Technical Bulletin #620

4R44E, 4R55E, 5R55E

Delayed Forward Engagement

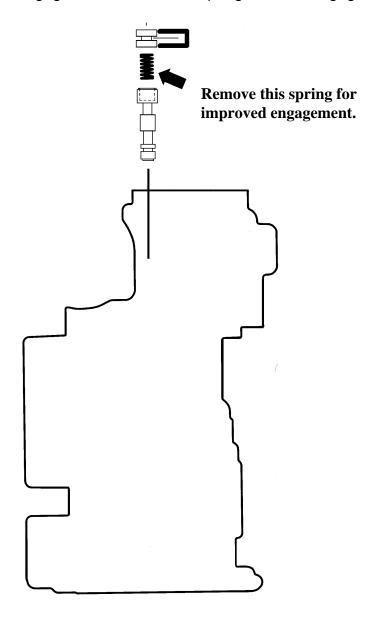
To improve forward engagement, remove the spring from the engagement control valve.
